INSPECTORS REPORT ON A LICENCE APPLICATION

To:	DIRECTORS	
From:	DR J DERHAM	- LICENSING UNIT
Date:	13/1/06	
RE:	APPLICATION FOR REVIEW OF A WASTE LICENCE FROM NEIPHIN TRADING LTD, LICENCE REGISTER W047-01

Type of facility:	Non-Hazardous Materials Recovery Facility & Non-Hazardous residual Landfill
Class(es) of Activity (P = principal activity):	3 rd Schedule: 5 (P), 1, 4, 6, 11, 12, 13 4 th Schedule: 2, 3, 4, 11, 13
Quantity of waste managed per annum:	630,000 t
Classes of Waste:	Construction & Demolition, Commercial, Industrial and compostable wastes. Waste excavated on site.
Location of facility:	Kerdiffstown, Naas, Co. Kildare
Licence review application received:	30 July 2004
Third Party submissions:	Seven
EIS Required:	No
Article 14 Notices sent:	13 Oct 2004
Article 14 compliance date:	17 December 2004
Additional Information to file:	11 November 2004, 24 October 2005
Site Inspections:	23/9/04, 04/10/05

Figure 1: Site location & extent, also indicating Review application extension area.

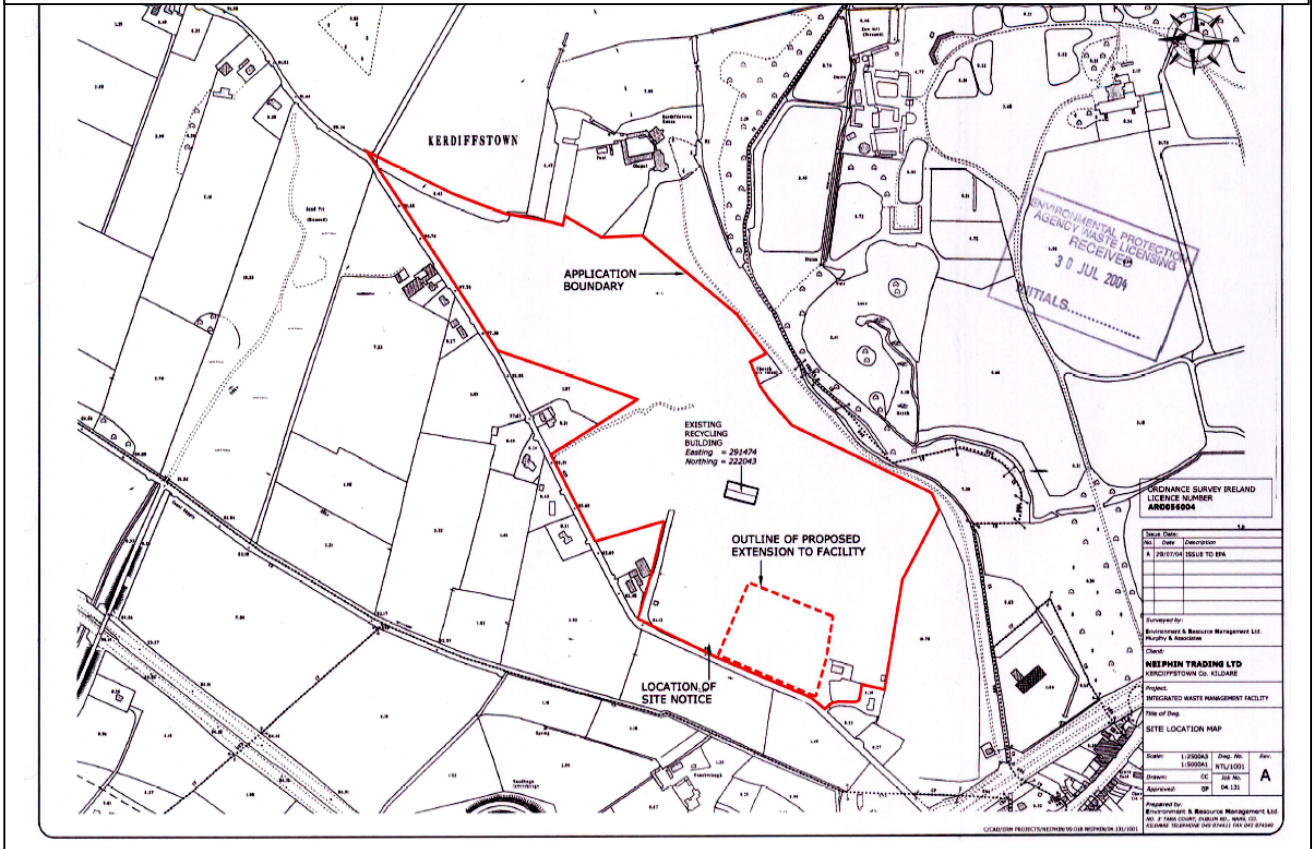
- Small amendment to facility boundary to regularise new ownership limits: involving removal of historically placed waste in this area, and extension of engineered landfill (see Figures 1 & 2 attached).
- Regularisation of the final approved contours for the finished landfill between planning permission and EPA licence. The revised planning permission states 108m AOD, whereas Condition 4.2 of Waste Licence W047-01 specified 100m AOD. The applicant wants the EPA licence to be consistent with the planning specifications.
- Inclusion of composting in authorised processes (in-vessel with biofilters), including disposal of residues of such processes. This change necessitates Classes 6, 11 & 12 of the Third Schedule to the Waste Management Acts to be added to the list of approved activities for the site.
- Addition of household derived recyclables to approved waste streams.

The alteration to the site boundary subject of this review increases the size of the licensed area from 28.3ha to 30.6ha. The infrastructure within this area includes: waste processing buildings & equipment for separation and recovery of industrial, commercial, C & D and compostable waste streams, with the residual being disposed to on-site landfill. The whole operation could be described as a materials recovery facility (MRF) and residuals landfill. The estimated capacity of the on-site residual landfill is 3.6Mm³.

The changes to the site operations arising from the review do not present and significant addition to the emissions profile and impact of the operation. Some construction related noise and dust may be likely during development of the small extension to the landfill cells in the south east of the site (refer figure 2). This will be short term in nature and the works will be located some distance below the external landscaped area of the site. Standard BAT measures for control of these nuisances are required in the RD. The additional waste streams to be accepted (though no increase in volumes consented in Licence Register 47-01) for feedstock to the composting units will be accepted and processed within the site buildings.

Figure 2: Proposed landfill development sequence.

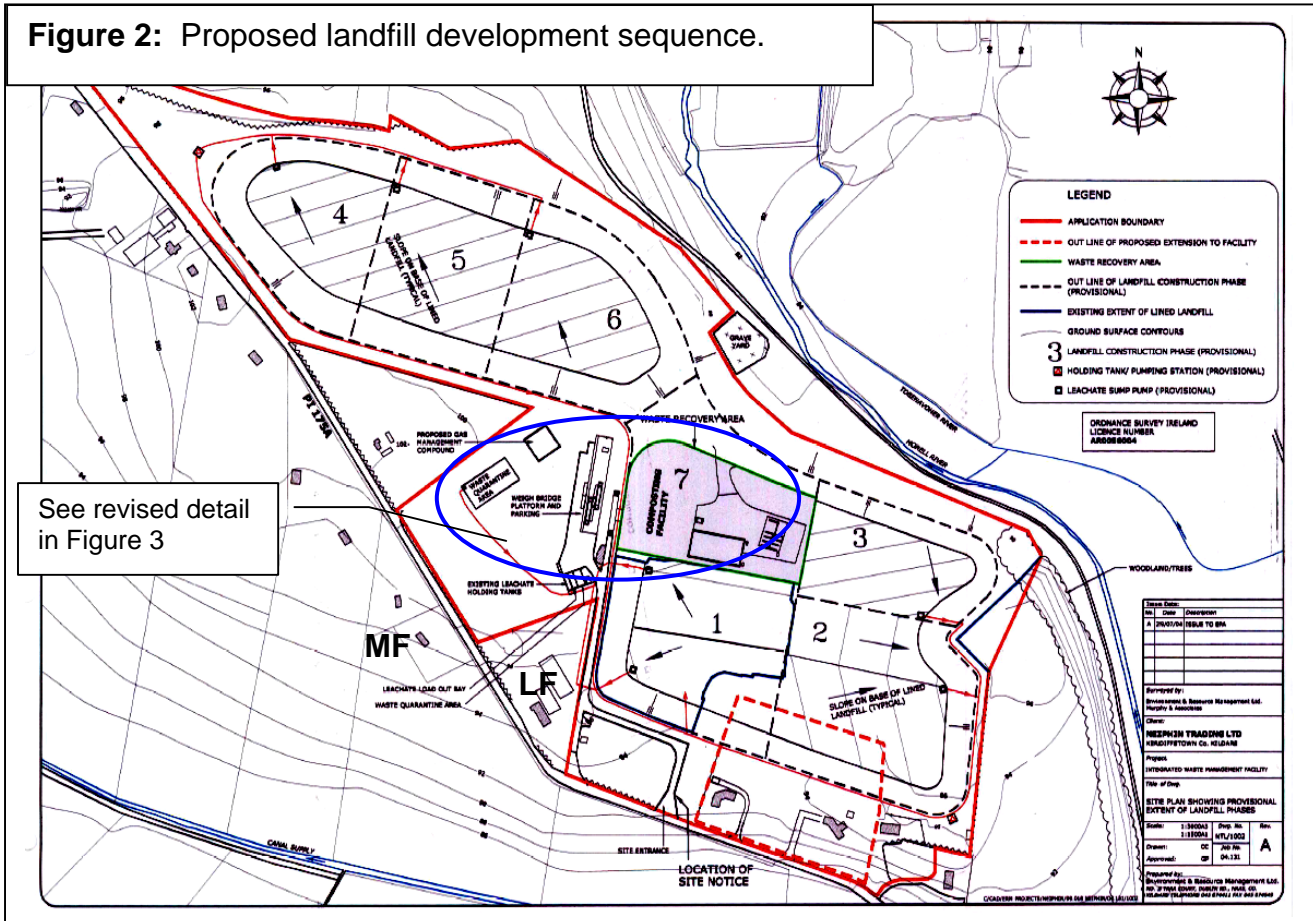
not easily obtained for the casual or infrequent visitor to the site (such as myself). It is clear that the operator is excavating/has cleared, areas 1, 2, 3 & 7 of illegal waste (Figure 2). However, the increase placement of part-processed material in the north-western part of the site suggests that a deal of the material flows (albeit with some recovery of the likes of wood, metals, etc.,) are not clearly positive on the off-site-export side of the preferred equation – i.e. a lot of internal handling and replacement. I expect that when landfill cells 1 and 2 are completed (including accounting for the boundary change) and landfilling of un-recoverable residual waste commences in earnest, that greater efforts to tackle the north-western part of the site will be logistically easier for the operator. By that time the current infrastructure development program should be completed, thereby allowing the operators even greater time to concentrate on remediation of the illegally deposited areas, and the sourcing of off-site recovery solution for the various recovered waste streams.

The Foley's are the nearest resident to the central waste processing areas of the facility (see location 'LF' on Figure 2). They made two submissions on the application (received 31/8/04 and 7/2/05). The Foley's believe it is premature to allow expansion of processes/activities at the site, and the import of 'domestic' waste for treatment is not acceptable to them. The current licence is not long in existence and landfilling has not yet commenced – the applicant has not proved their capabilities yet. They believe that the licence cannot be operated in a manner that prevents emissions from impacting on them. In particular the submission raises concerns in relation to dust and noise. They comment that complaints have been lodged with the EPA regarding nuisance.

Comment:- The M Foley's live in the house labelled 'MF' on Figure 2 above. I refer to the matters discussed in part 11.1 above insofar as they address some of the concerns raised by the M Foley's. On the matter of health impact for composting operations it is notable that the composting units are of the enclosed design, with feed-stock being received and prepared in an enclosed and connected building. The high temperature of the composter design will reduce the potential for spores/bio-aerosols in the exhaust air: and in addition the exhaust air from the feed preparation building and the composters is to be passed through a biofilter, further reducing dust and spore release potential. The spore generation potential is unlikely to result in any appreciable increase in bio-aerosols in the area given the mixed land use of amenity/residential/agricultural/industrial. The M Foley's are more than 200m upwind (prevailing) of the proposed composting units. The design of the composting units and the pre-processing building, as well as their location with respect to the M Foley's will also mitigate against odour impact potential. The maturing or curing of the compost may take a number of weeks, the licence conditions require the careful control of the compost quality such that the potential for odour generating during curing is reduced. In addition Condition 3 requires that no compost is stored for curing within 200m of a sensitive receptor. These provisions represent BAT, accordingly no adverse health implications are expected.

It is considered important that the landscaping measures for noise and dust mitigation be implemented immediately along the south-western boundary of the site. Condition 6 deals with this matter. In addition the operator is required in Condition 3 to install a 2m high constructed engineered specification acoustic barrier between the L Foley's residence and the operational areas.

As regards the proposed location for the landfill gas extraction plant I would recommend that this be located in an area away from sensitive receptors. The current proposed location is to locate the plant c.200m north of the L Foley's (and c.120m east of another private residence. Such units can represent a noise and odour nuisance risk. They are also 24hour noise sources. This has to be considered against the applicants proposals to recover c.95% of the waste processed on the site and with composting reducing the gas production capacity of the residual, it is expected that gas generation potential in the completed landfill will be significantly less than that associate with a conventional mixed waste landfill facility. Nevertheless, Condition 3 requires the gas plant should not be located within 250m of private residences. On the general concern of nuisance arising from the waste disposal activities in Cell 1 being close to the residence of the L Foley's, and having regard to the variation in waste types, the RD includes a condition (Condition 8) prohibiting the placement of any waste, other than inert waste, within 100m of any private residence (including the L Foley's).
